Santa Ana Regional Water Quality Control Board

**COMMENTS ON REQUESTED ALTERATION OF STOCKPILE H TO
ACCOMMODATE TRUCK HAULING ROUTE FOR PROPOSED MABURY
RESIDENTIAL DEVELOPMENT – RIO SANTIAGO, 6145 E. SANTIAGO CANYON
ROAD, ORANGE, CA (GLOBAL ID NO. T10000023109; CR SITE ID NO. 2080228)**

Santa Ana Regional Water Quality Control Board (Santa Ana Water Board) staff have reviewed *Requested Alteration of Stockpile H to Accommodate Truck Hauling Route for Proposed Mabury Residential Development* (Requested Alteration), dated December 10, 2025, for Rio Santiago, located at 6145 East Santiago Road in Orange (Site). The Requested Alteration was prepared on your behalf by your consultant, Verdantas Inc. (Verdantas) and submitted to the Orange County Health Care Agency (OCHCA) and the Santa Ana Water Board. This letter provides our comments on the Requested Alteration.

TR 18163 HAUL ROUTE EXHIBIT -C

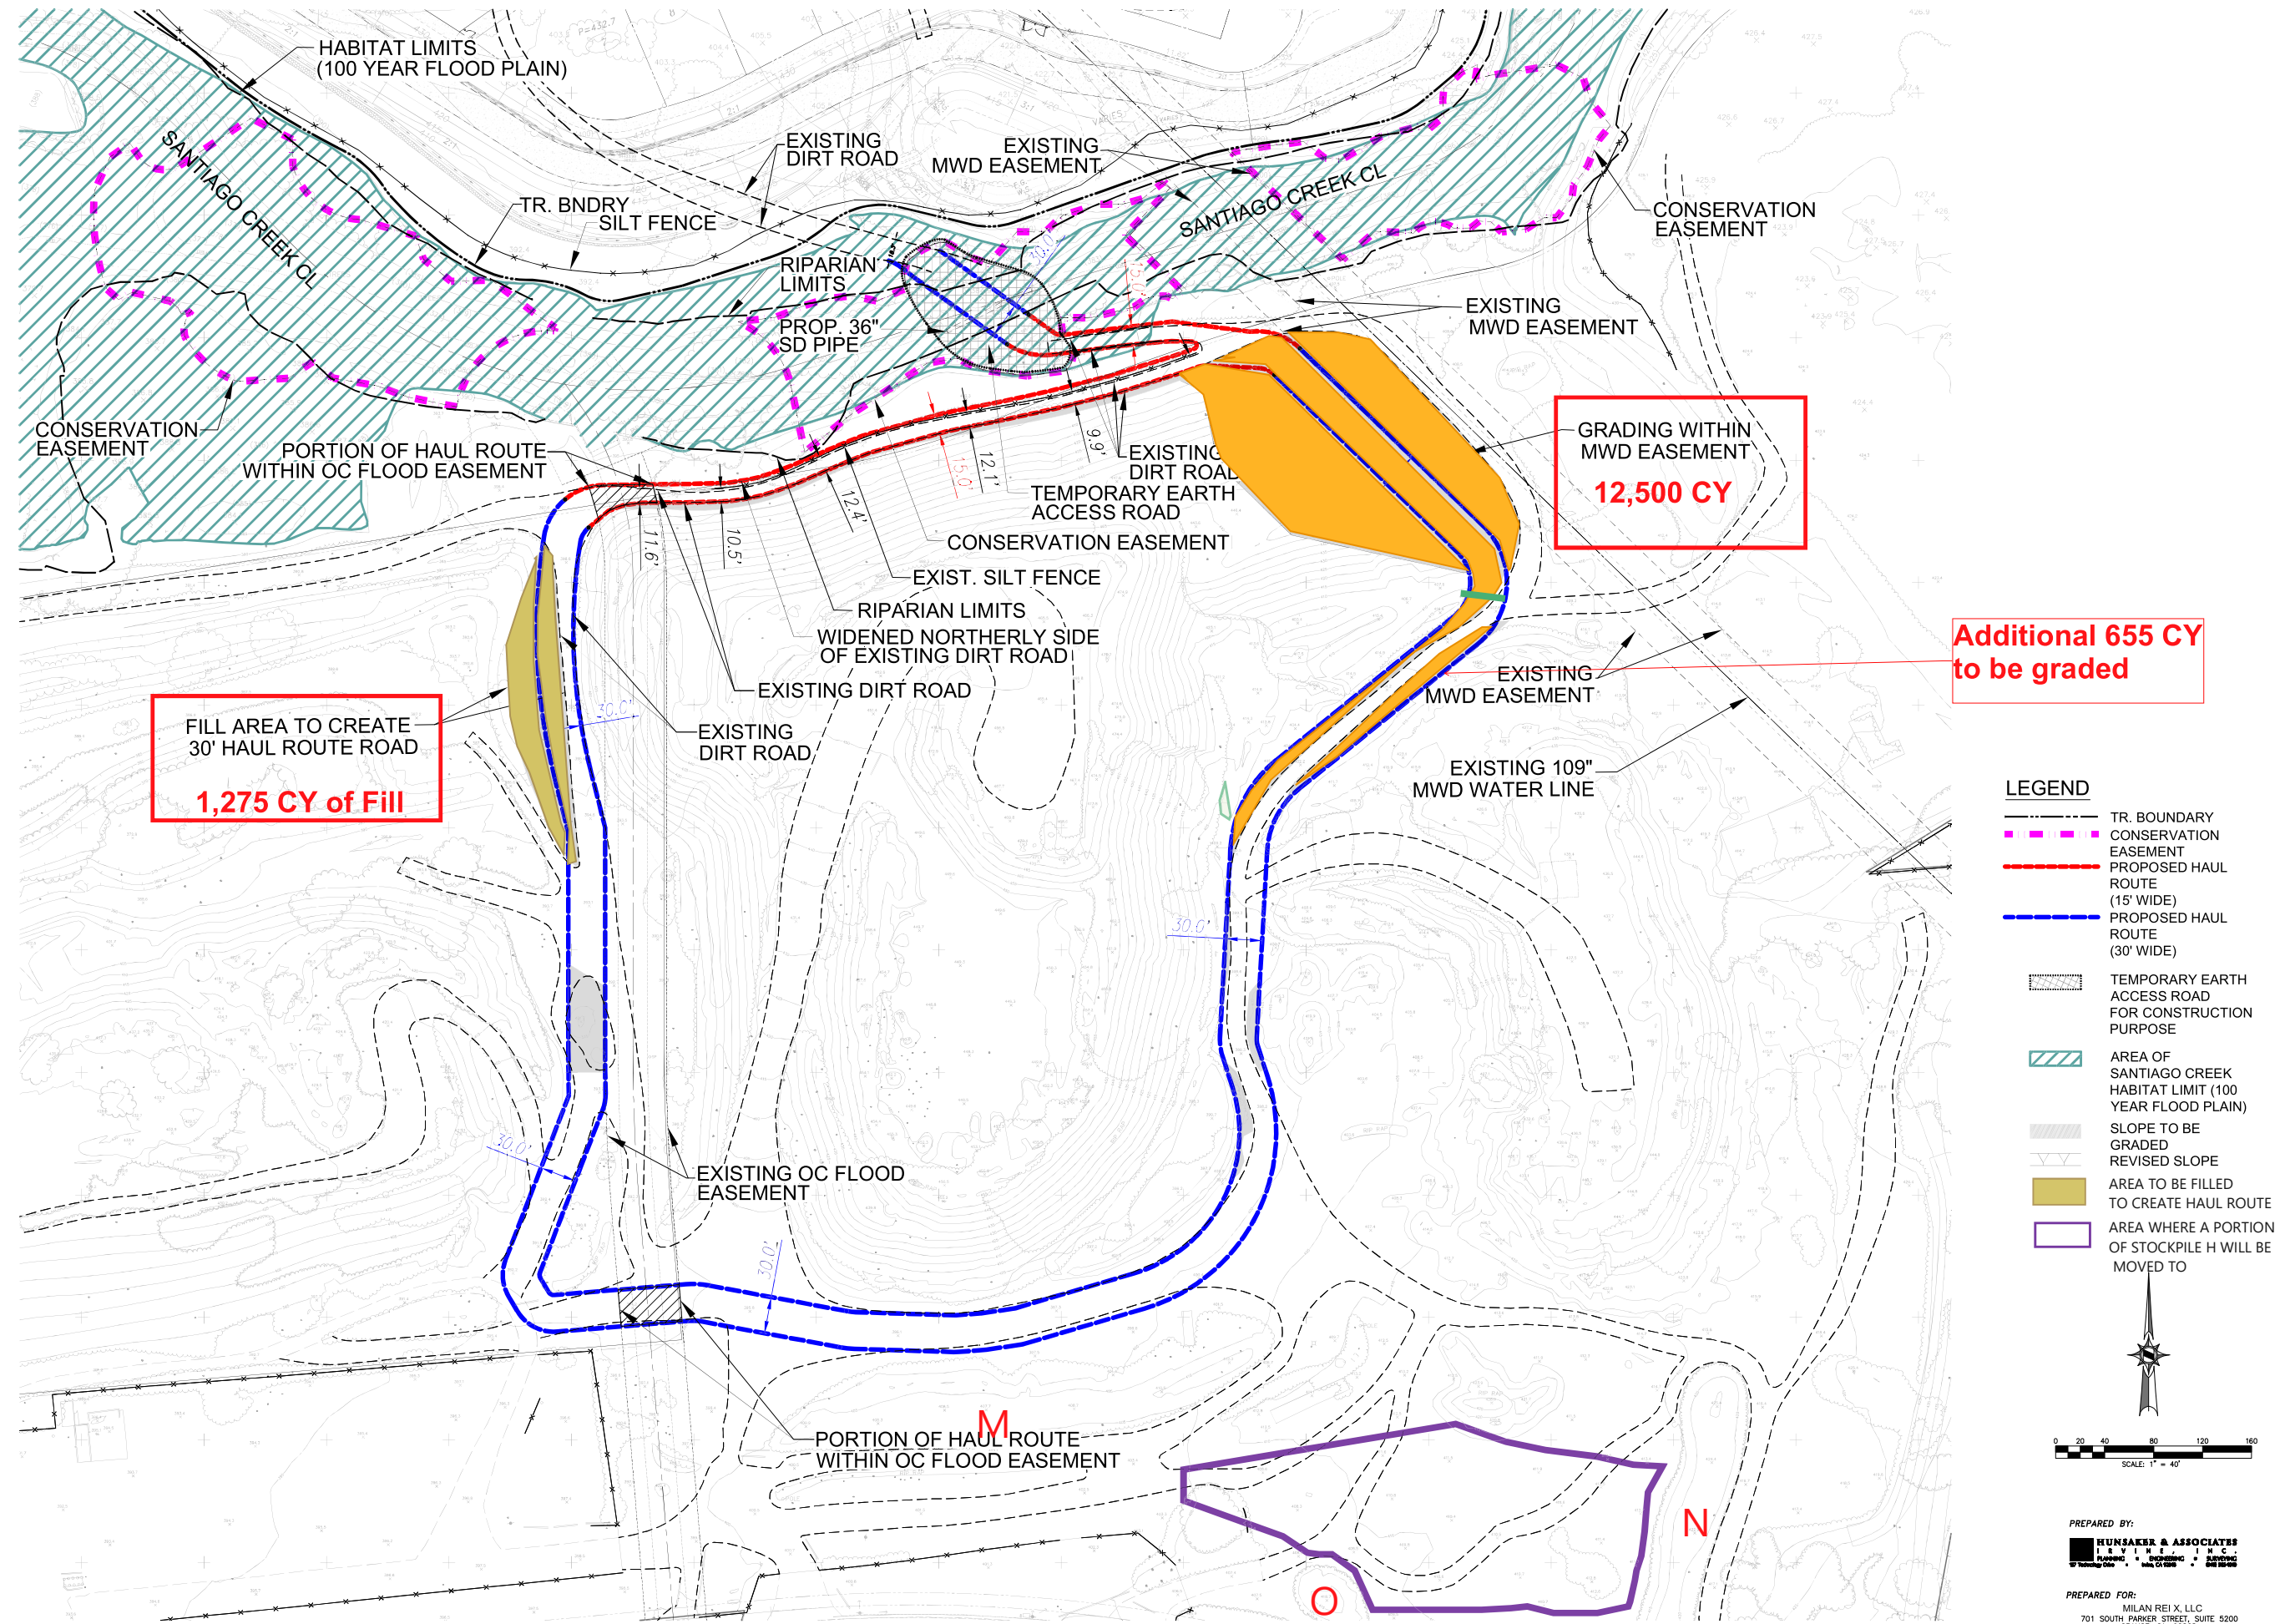
- Relocation of approximately 12,765 cubic yards (CY) of soil from Stockpile H to two areas on the Site.
 - Per an email from Mr. Nicholson, dated December 22, 2025, the lower ten feet of Stockpile H will not be moved or disturbed as part of the alteration.
- Approximately 1,275 CY of the 12,765 CY of Stockpile H soil will be emplaced in the area depicted in olive green (Attachment 1) to provide the fill needed to widen a portion of the proposed haul route.
 - The depth of the area to be filled is approximately 10 to 15 feet.
 - The maximum width of the area to be filled is approximately 40 to 45 feet.

- The remaining balance of Stockpile H soil proposed for relocation, approximately 11,490 CY, will be moved to and re-stockpiled at the area outlined in purple (Attachment 1).
- A California-licensed Professional Land Surveyor will conduct a survey of Stockpile H and the proposed soil relocation areas to provide “before and after” topographic exhibits.
- Engineering controls, as listed below, will be used to help prevent soil from migrating off-Site:
 - Municipal water will be continuously applied, as needed, to disturbed soils during loading, transportation, and emplacement to mitigate airborne fugitive dust emissions
 - Shaker/track plates will be installed on the Rio Santiago Site side of the proposed temporary earthen bridge to mitigate soil transfer originating from the Site to the Mabury site.

The Santa Ana Water Board prefers that imported clean fill material be used for the haul route area that needs to be filled. However, the use of material from Stockpile H, as described above, is acceptable to fill in the area needed for the on-Site haul route. Regardless of where the fill material is sourced from, the Santa Ana Water Board may require sampling of the haul route fill area in the future, if warranted.

1. Ensure that no visible dust migration is observed during stockpile grading and relocation activities, including during non-working hours. Refer to Department of Toxic Substances Control (DTSC)’s *Community Air Monitoring Plan Guidance* and

South Coast Air Quality Management District (SCAQMD) Rule 1466, as needed, for protocols to minimize and address fugitive dust emissions during field work for the Stockpile H alteration.

2. Ensure that appropriate erosion prevention controls are used to prevent material from Stockpile H from migrating to areas outside of the Stockpile H footprint or the approved relocation areas.
3. Ensure that no other on-Site stockpiles are disturbed or impacted during alteration and relocation activities for Stockpile H.
4. If imported clean fill material is used for the haul route fill area, provide the source facility name and address to the Santa Ana Water Board prior to the emplacement of the fill material.
